Power System Security and Reliability (PSSR) Standards Review: Exposure Draft

Proposed Electricity System and Market (ESM) Amending Rules

Explanatory Note for Exposure Draft of the Proposed ESM Amending Rules

Part 1: Amending Rules to clarify Technical Requirements for connecting inverter-based technologies

Figure A12.3.2.1: Example Reactive Power Capability required to meet ~~Ideal Generator Performance Standard~~ Automatic Access Standard

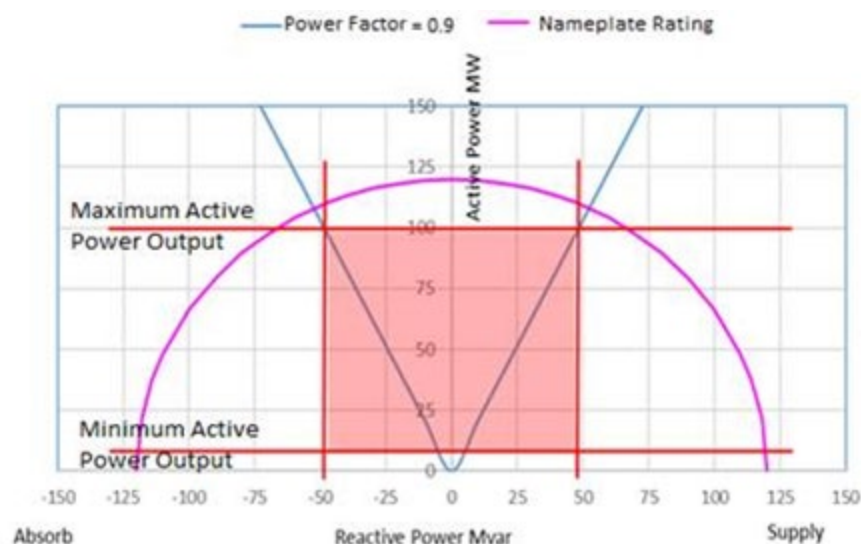
- A12.3.2.1. For all operating conditions including temperatures up to and including the Maximum Temperature, each Generating Unit within the Generating System must be capable of supplying or absorbing Reactive Power continuously of at least the amount equal to the product of ~~the Rated Maximum Active Power output of the Generating Unit at nominal voltage~~ the applicable Active Power output level achievable at any temperature, as specified in the Temperature Dependency Data under Part A12.2 and 0.484 while operating at any level of Active Power output between its ~~maximum Active Power output level as specified in the Temperature Dependency Data under Part A12.2~~ Maximum Active Power, and its Rated Minimum Active Power output level.

Figure A12.3.3.1: Example Reactive Power Capability required to meet the ~~Minimum Generator Performance Standard~~ Minimum Access Standard

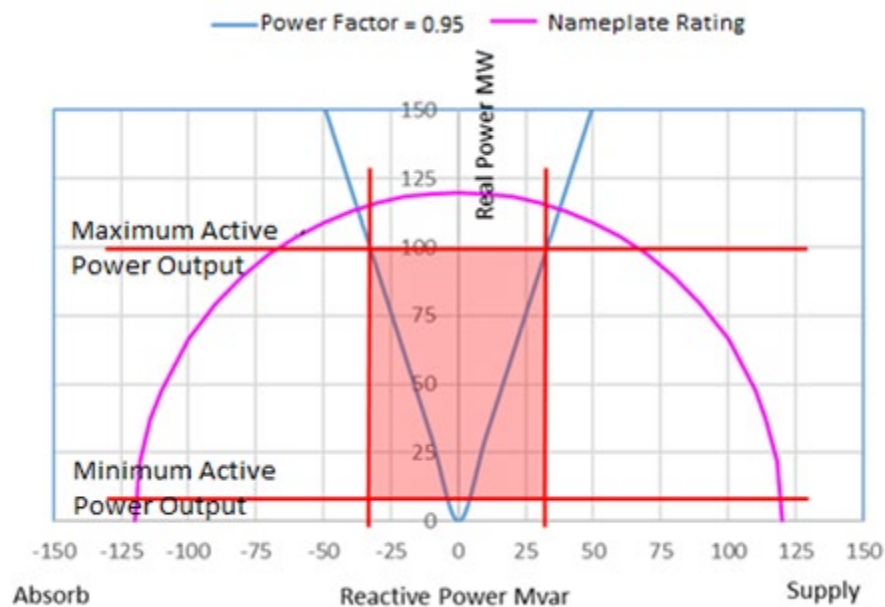
Clauses A12.3.2.1 and A12.3.3.1 are amended to improve the accuracy of the provision and avoid potential misinterpretation that could require a Market Participant to provide maximum active power capability at all temperatures regardless of any applicable derating.

- A12.3.3.1. Subject to clause A12.3.3.3, for all operating conditions including temperatures up to and including the Maximum Temperature, the Generating System must be capable of supplying or absorbing Reactive Power continuously of at least the amount equal to the product of the ~~Rated Maximum Active Power output of the Generating System~~ the applicable Active Power output level achievable at any temperature, as specified in the Temperature Dependency Data under Part A12.2 and 0.329 while operating at any level of Active Power output level between its ~~maximum Active Power output level as specified in the Temperature Dependency Data under Part A12.2, Maximum Active Power~~ and Rated Minimum Active Power output level.

Figure A12.3.3.2: Relaxation of Reactive Power requirement with Connection Point voltage

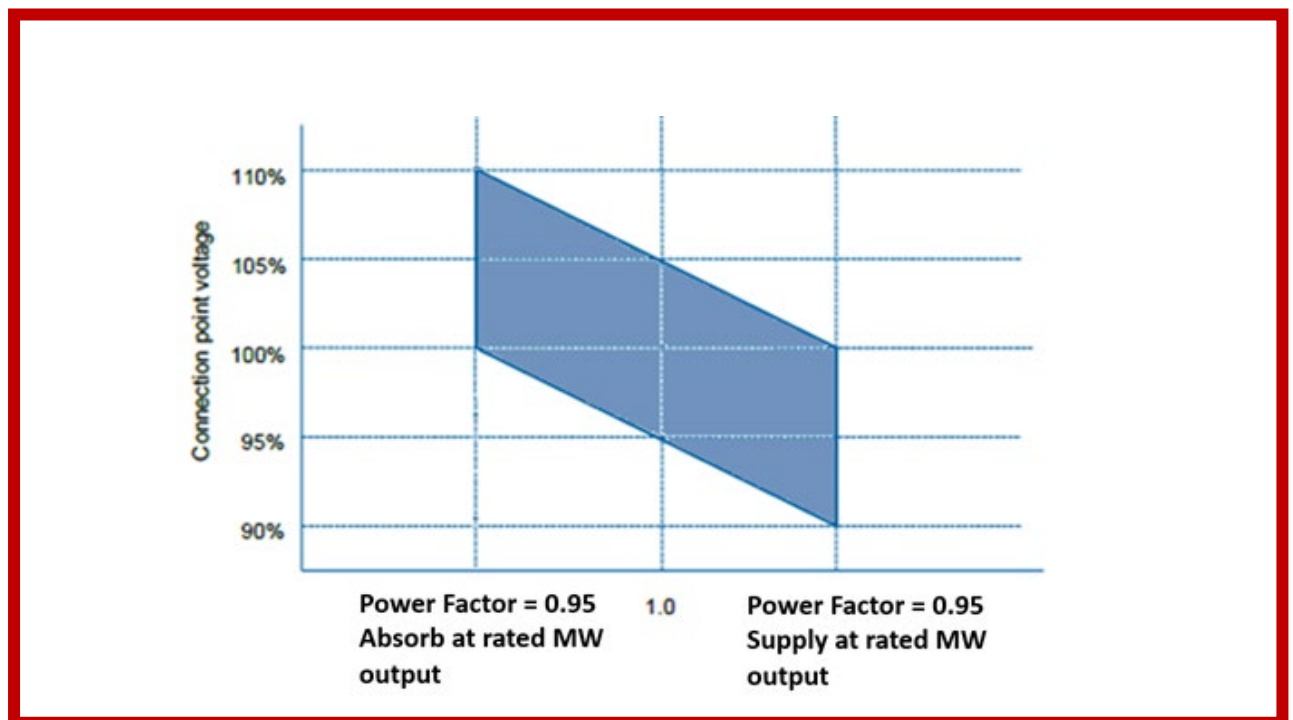
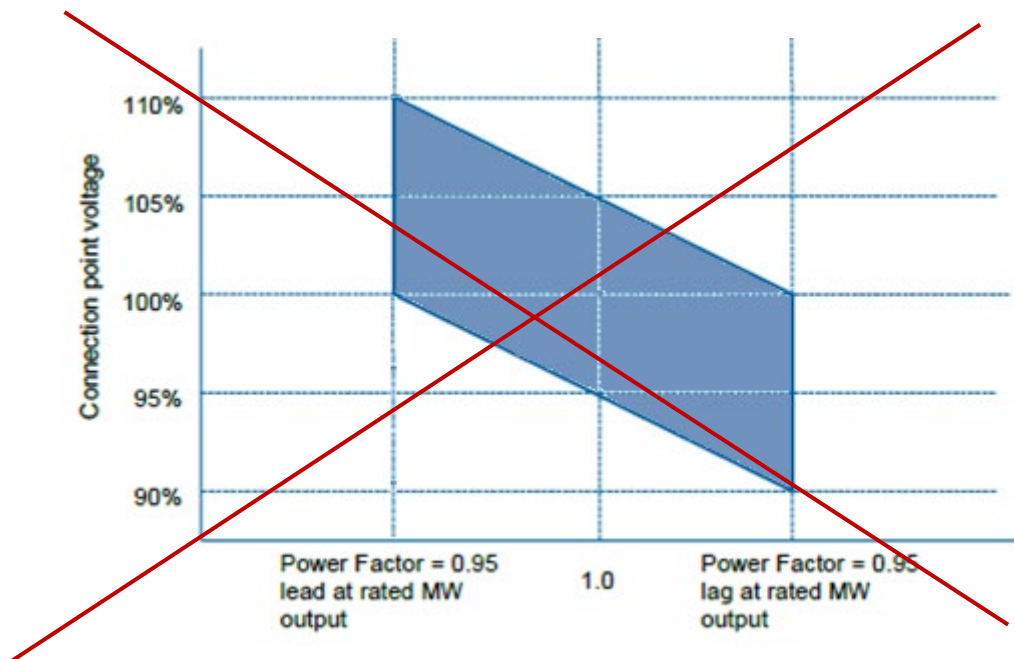
The x-axis of Figure A12.3.3.2 is amended to replace 'lead' and 'lag' with 'Absorb' and 'Supply', aligning the terminology with clause A12.3.3.2 and making it applicable to ESRs.

- A12.3.3.2. The Reactive Power Capability may be varied as shown in Figure A12.3.3.2 when the voltage at the Connection Point varies between 0.9 per unit and 1.1 per unit, where the Generating System must be capable of absorbing or supplying Reactive Power continuously when operating anywhere inside the curve specified in Figure A12.3.3.2.

Figure A12.7.2.1 Frequency variations that a Generating System must ride through to meet the ~~Ideal Generator Performance Standard~~ Automatic Access Standard

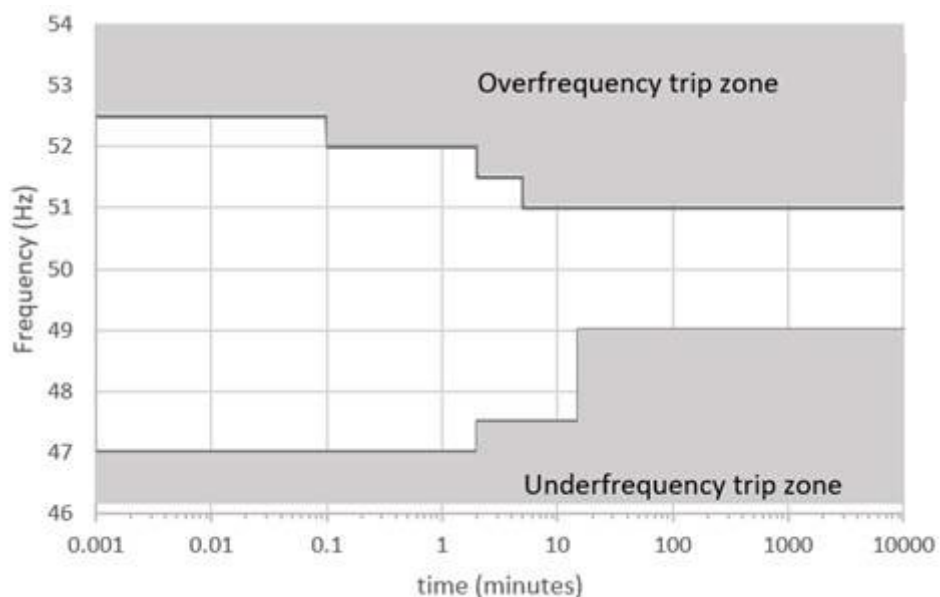
- The heading of Part A12.7.2, the title of Table A12.7.2.1 and clauses A12.7.2.1 and A12.7.2.2 are amended to apply the revised Access Standard terminology and the new defined term 'Disturbance'.
- Clause A12.7.2.1 is also amended to replace "up to" with "at least" to clarify the application of the timeframes specified in subclauses (a) to (e). This amendment aligns the drafting with the Generator Performance Standards Guideline and the National Electricity Rules and does not change the substantive operation of the clause.

- reach 52.5 Hz for a period of ~~up to~~ at least 6 seconds;
- reach 52 Hz for a period of ~~up to~~ at least 2 minutes;
- reach 51.5 Hz for a period of ~~up to~~ at least 5 minutes;
- operate between 49.0 Hz to 51.0 Hz continuously;
- reach 47.5 Hz for a period of ~~up to~~ at least 15 minutes; or
- reach 47.0 Hz for a period of ~~up to~~ at least 2 minutes,

Figure A12.7.3.1: Frequency variations that a Generating System must ride through to meet the ~~Minimum Generator Performance Standard~~ Minimum Access Standard

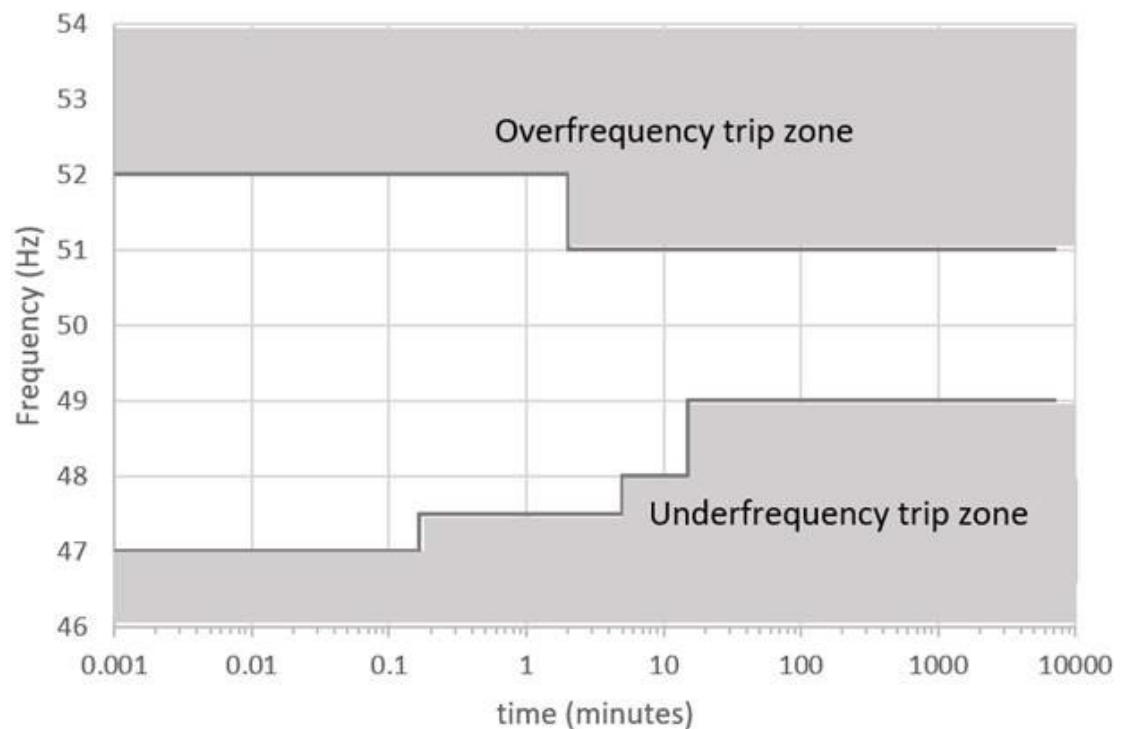
- The heading of Part A12.7.3, the title of Table A12.7.3.1 and clauses are amended to apply the revised Access Standard terminology and the new defined term 'Disturbance'.
- Clause A12.7.3.1 is also amended to replace "up to" with "at least" to clarify the application of the timeframe specified in subclause (a) and to align the drafting with the remaining subclauses.

- (a) reach 52.0 Hz for a period of ~~up to~~ at least 2 minutes;
- (b) operate between 49.0 Hz to 51.0 Hz continuously;
- (c) reach 48.0 Hz for a period of at least 15 minutes;
- (d) reach 47.5 Hz for a period of at least 5 minutes; or
- (e) reach 47.0 Hz for a period of at least 10 seconds,

Figure A12.8.2.1: Voltage variations that a Generating System must ride through to meet the ~~Ideal Generator Performance Standard~~ Automatic Access Standard

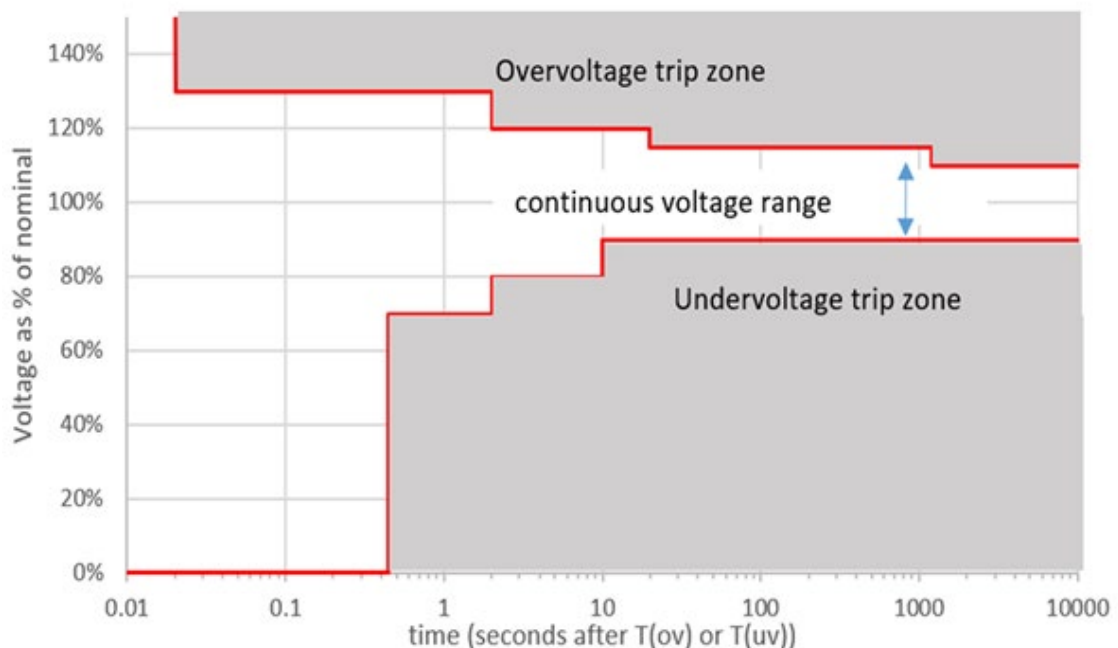
- The heading of Part A12.8.2, the title to Figure A12.8.2.1 and clause A12.8.2.1 are amended to apply the new revised Access Standard terminology and the new defined term 'Disturbance'.
- Clause A12.8.2.1 is also amended to clarify the applications of timeframes specified in sub-clauses (a) to (h). The amendments align the drafting with the Generator Performance Standards Guideline and the National Electricity Rules and does not change the substantive operation of the clause
- New clause A12.8.2.2 is inserted to align the Automatic Access Standards with the corresponding Minimum Access Standard requirements.

Figure A12.8.3.3: Voltage variations that a Generating System must ride through to meet the Minimum Generator Performance Standard Minimum Access Standard

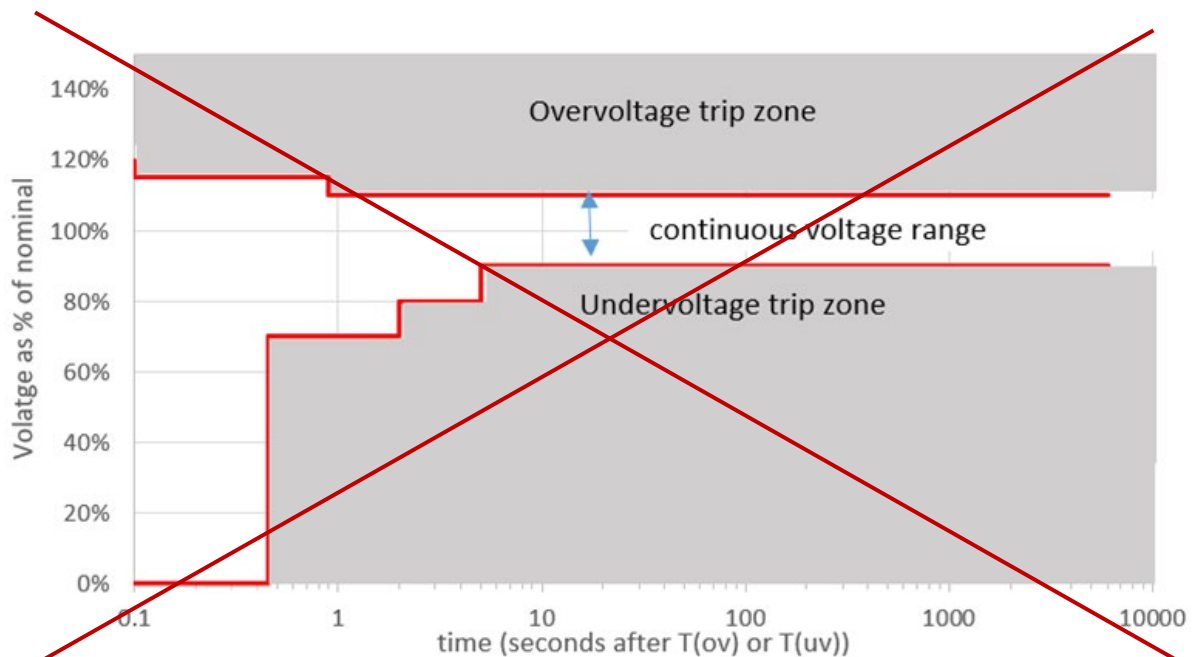
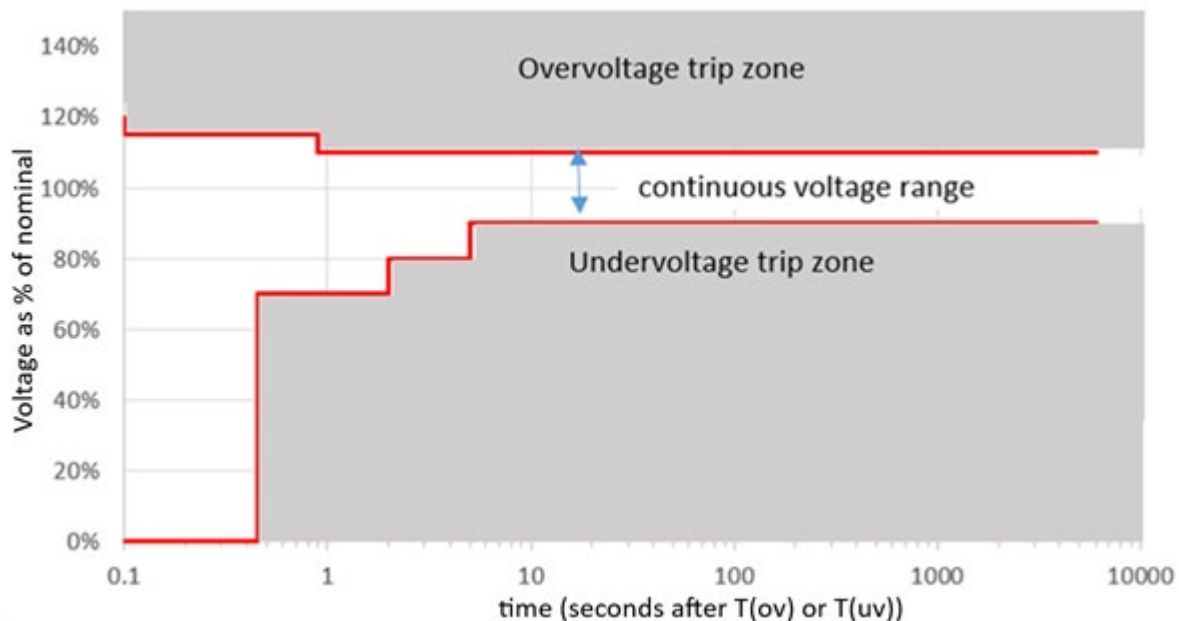
- The heading of Part A12.8.3, the title to Figure A12.8.3.1 and clause A12.8.3.1 are amended to apply the revised Access Standard terminology and the new defined term 'Disturbance'.
- Clause A12.8.3.1 is also amended to clarify the application of the timeframes specified in subclauses (a) to (h). The amendment aligns the drafting with the Generator Performance Standards Guideline and the National Electricity Rules and does not change the substantive operation of the clause.
- The figure for clause A12.8.3.3 is replaced to correct a typographical error in the spelling of 'Voltage'.
- New clause A12.8.3.4 implements review outcome 3.2 of the Information Paper by introducing a Minimum Access Standard for GFM IBRs requiring initiation of a response to oppose the positive-sequence phase angle jump within 20 milliseconds. This establishes a
